ADDENDUM TO THE CONTRACT DOCUMENTS

ADDENDUM NO. 002
	Project: Solano Community College District Building 1600 Modernization Project Project Number: 25-009
	Date: July 12, 2024

1 NEW FLOOR PLAN
SCALE: 3/16" = 1'-0"

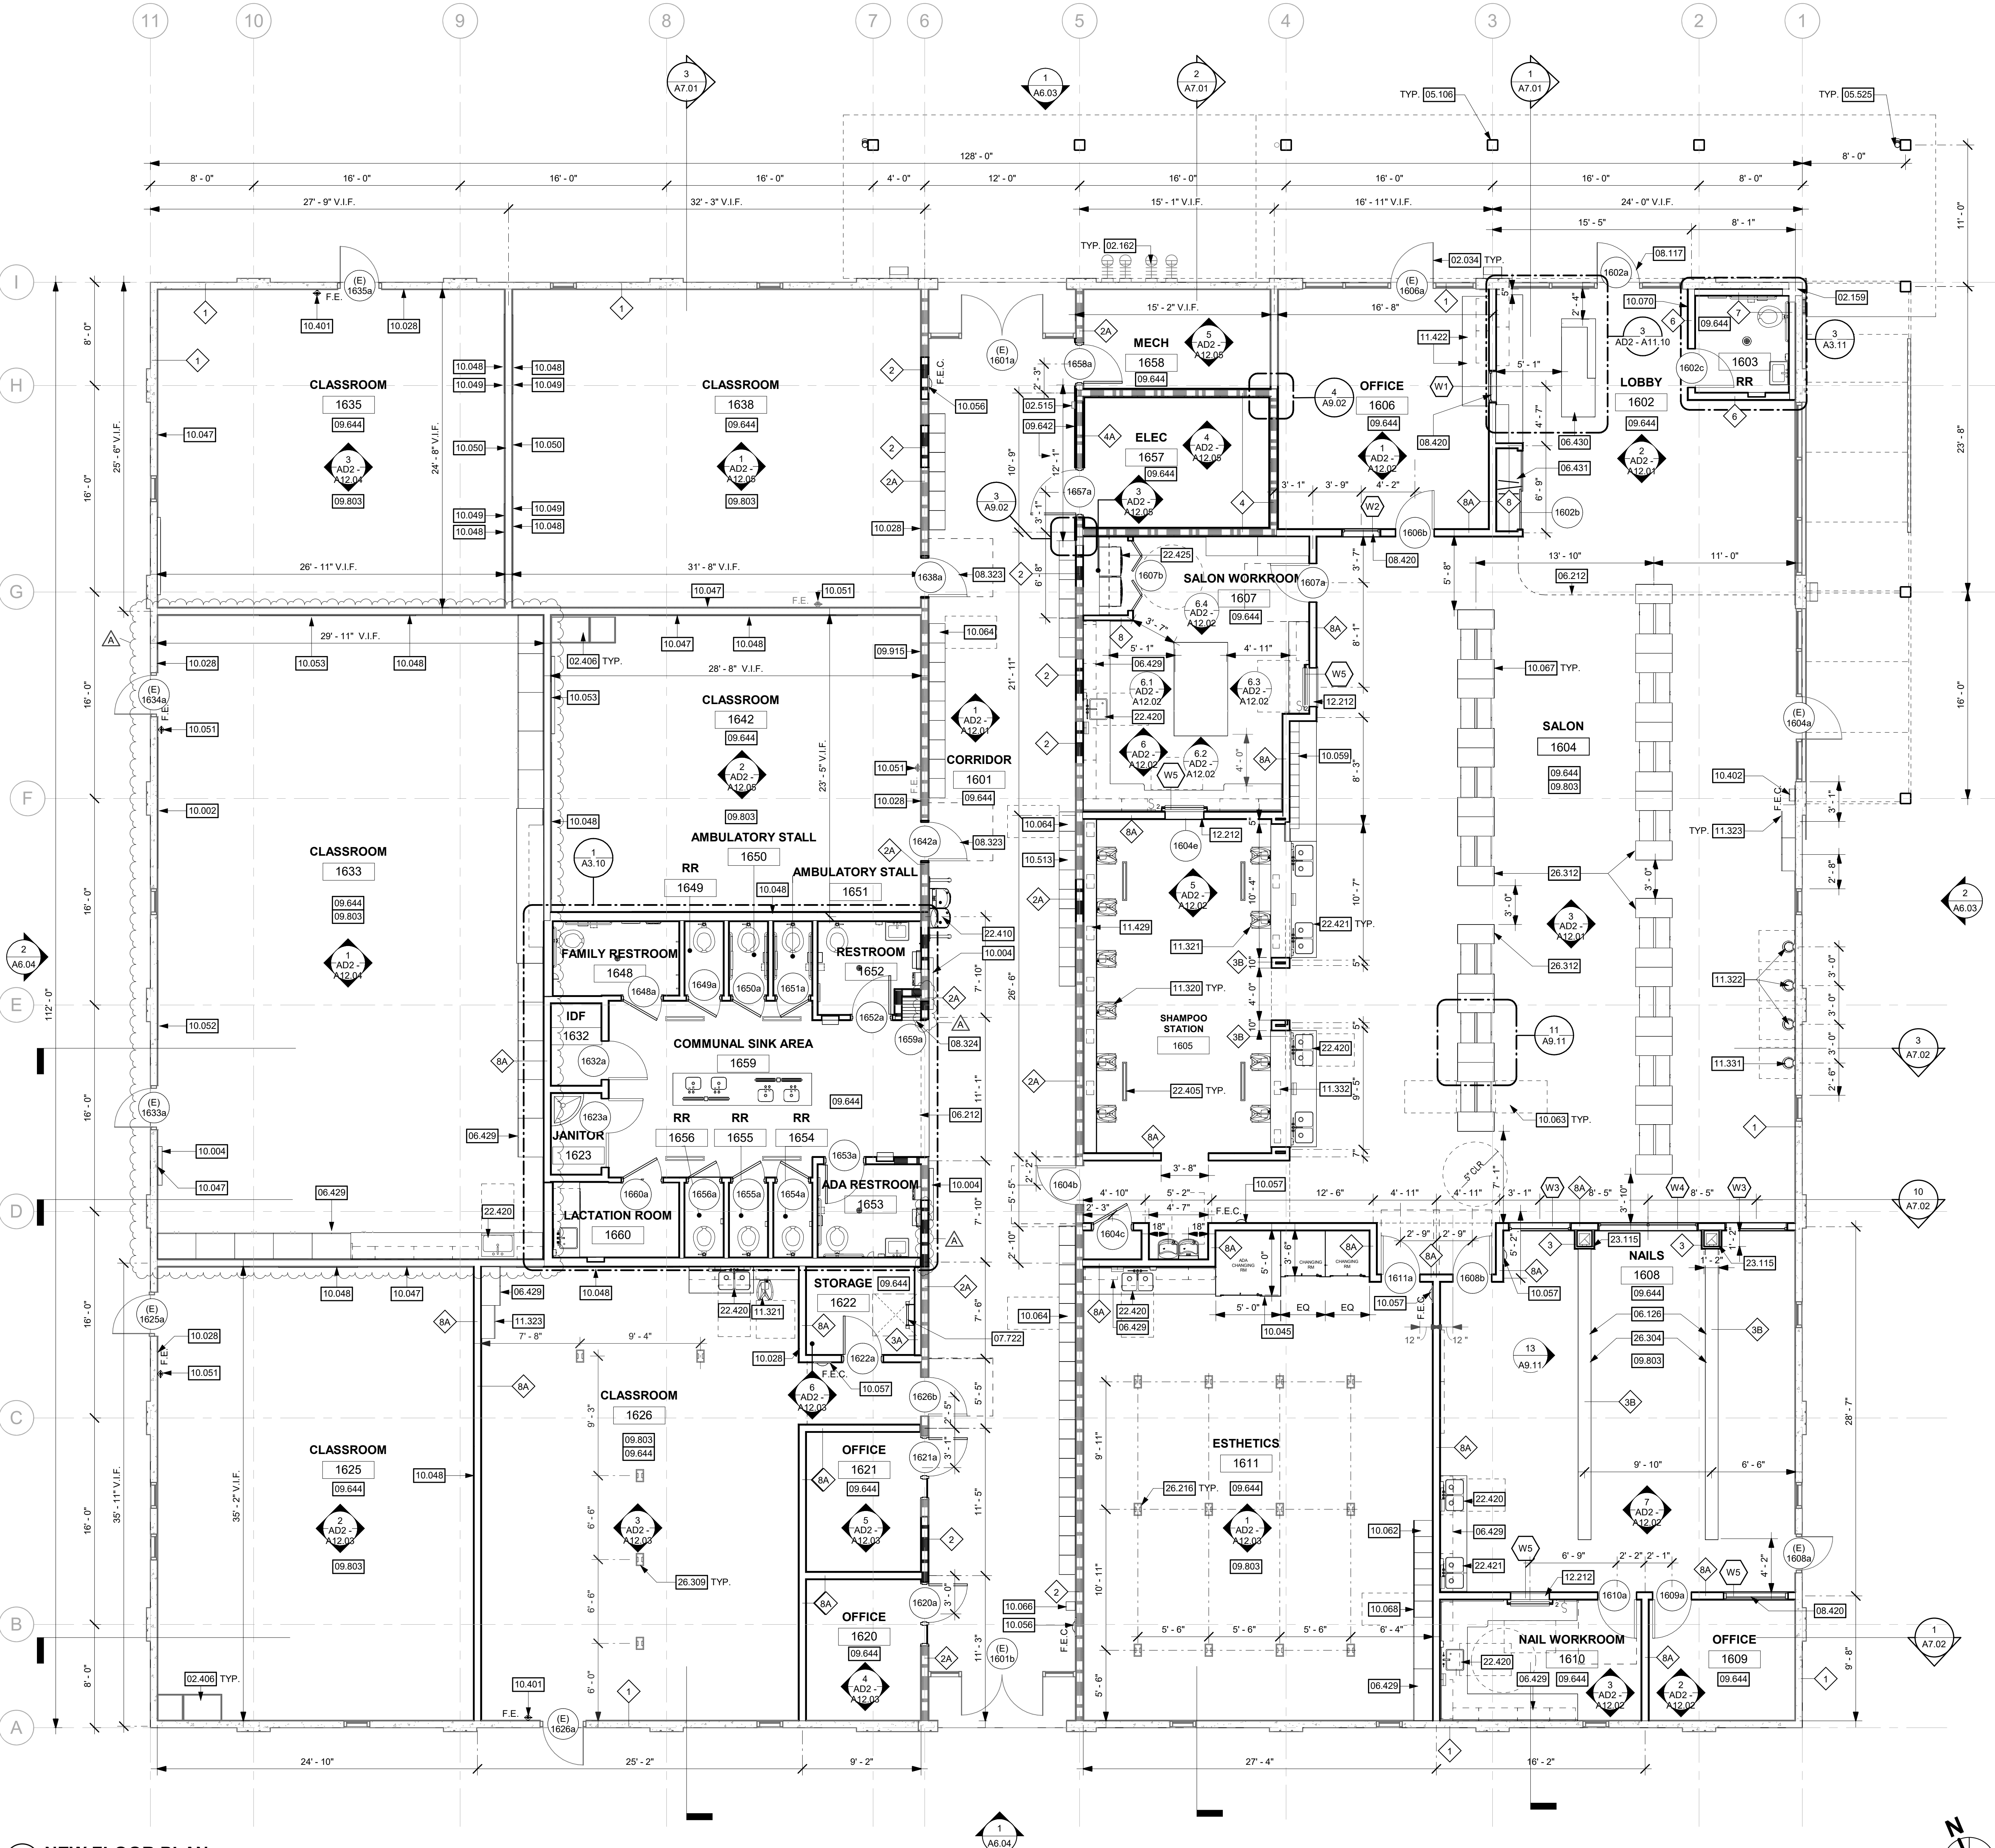
Add: General Note : " All interior and exterior doors to receive electronic door hardware U.O.N. See door schedule, electrical and technology drawings." as shown per attached sheet AD2-A3.01

Revise: Overall scope of merge Classroom 1633 and 1634 to one new classroom 1633 as shown per attached sheet AD2-A3.01

Revise: Wall layout on grid 6 between grid E and D as shown per attached sheet AD2-A3.01

4 COSMETOLOGY SIGN ATTACHMENT
SCALE: 1 1/2" = 1'-0"

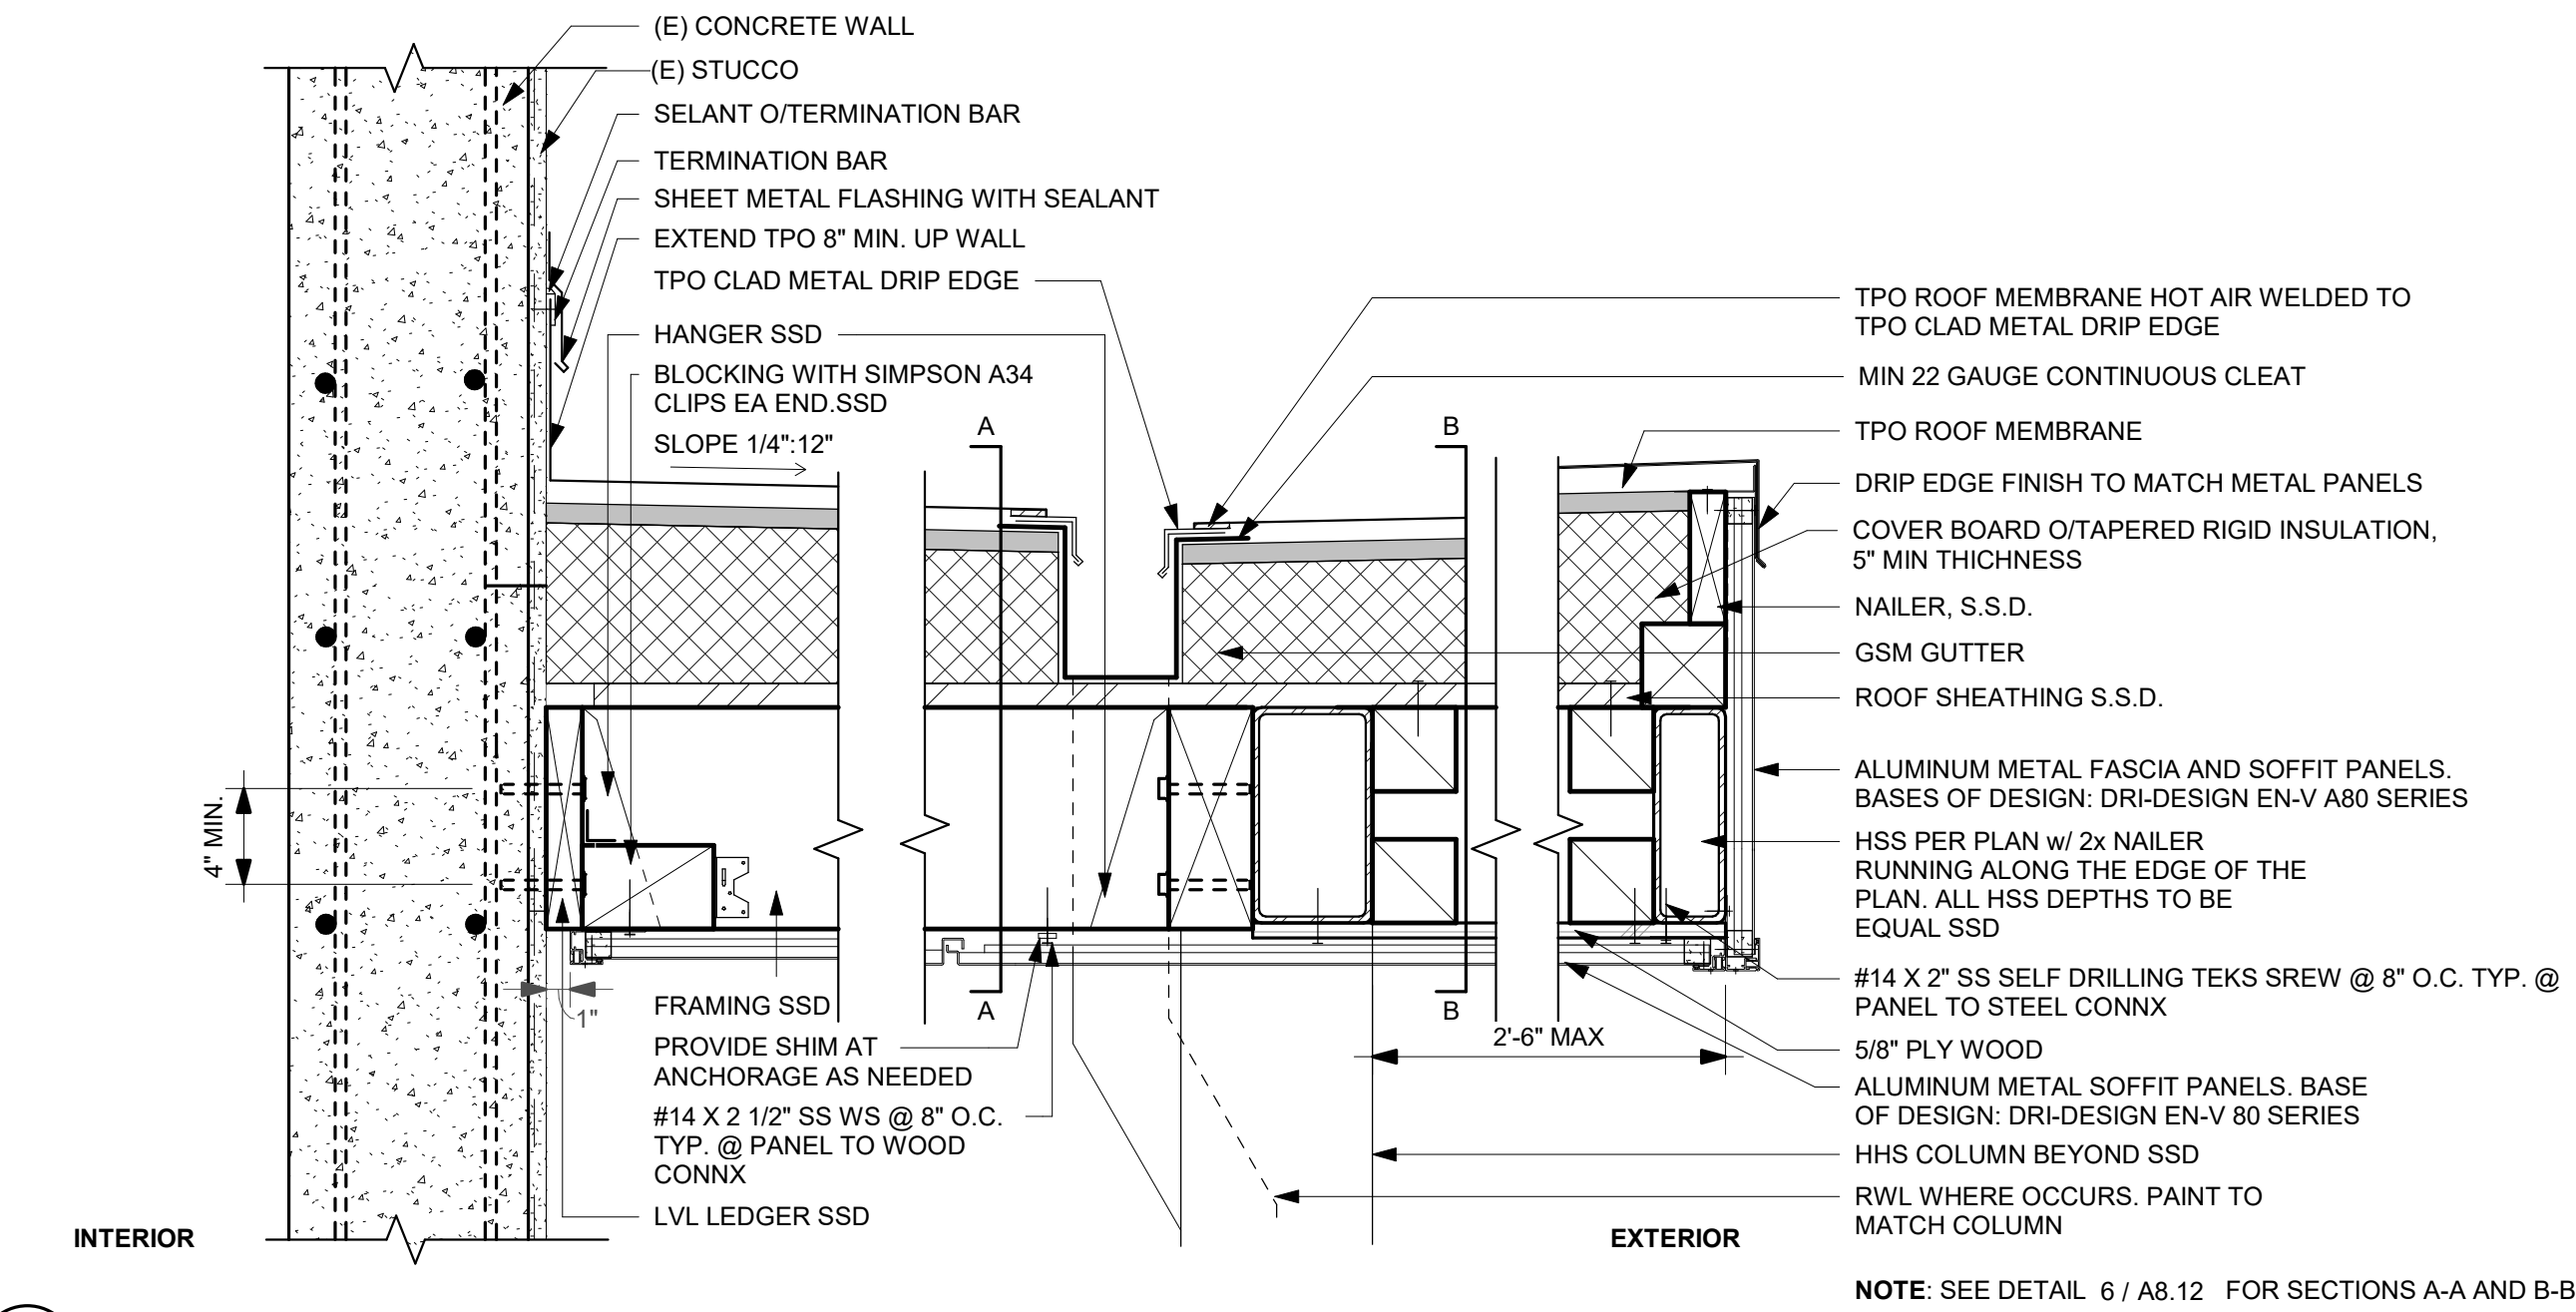
Revise: Detail 4 – "Cosmetology sign attachment" as shown per attached sheet AD2-A8.12.

Sheet S6.02 detail 11 shows the letters attached with a bolt from the backside of the channel into a threaded connection on the backside of letter. This would have the letters attached to the C5x8 channel prior to welding to the beam which would be difficult if not impossible to achieve with there being such a tight area between the backside of letter and beam. An alternate solution is required. Please advise

Revised design provided. See attached sheet AD2 – A5.03, detail 4 on sheet AD2 – A8.12 and detail 11 on attached sheet AD2 – S6.02 Canopy details

6 UPPER CABINET VALANCE DETAIL
SCALE: 3" = 1'-0"

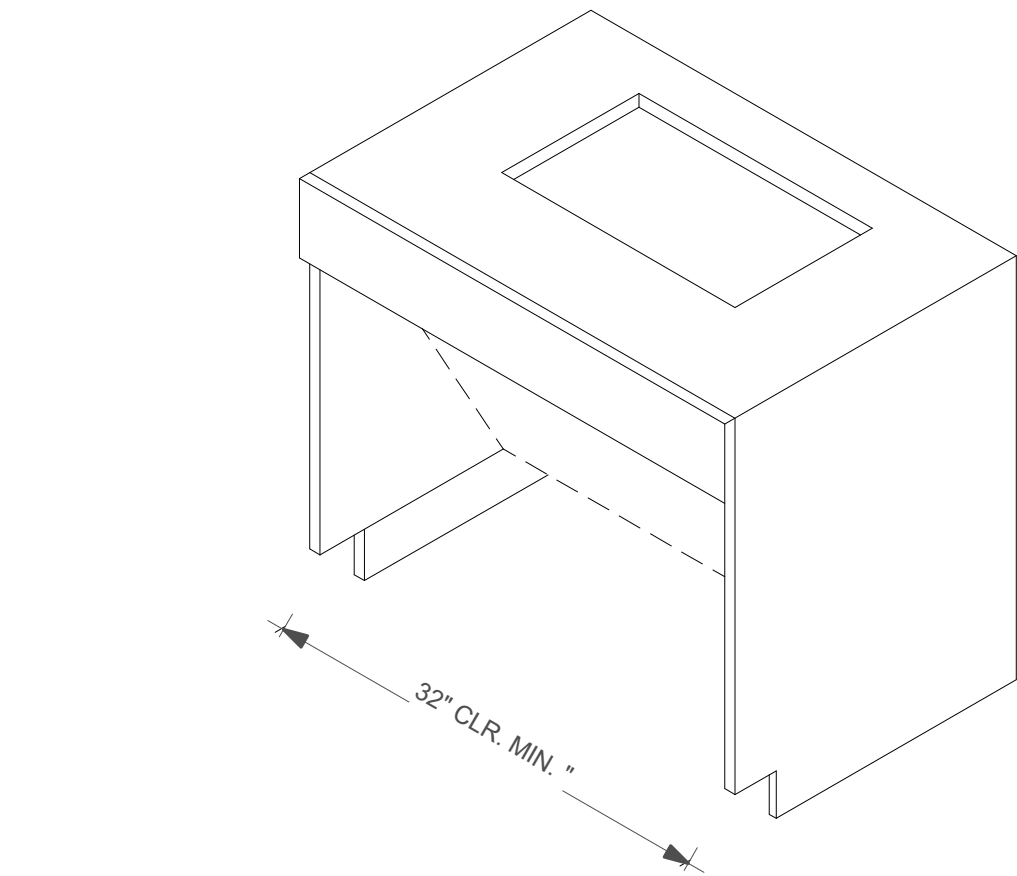
Revise: Annotation to read:" Under cabinet light. Where it applies. S.E.D." in Detail 6 – "Upper cabinet valance detail" as shown in attached sheet AD2-A11.10
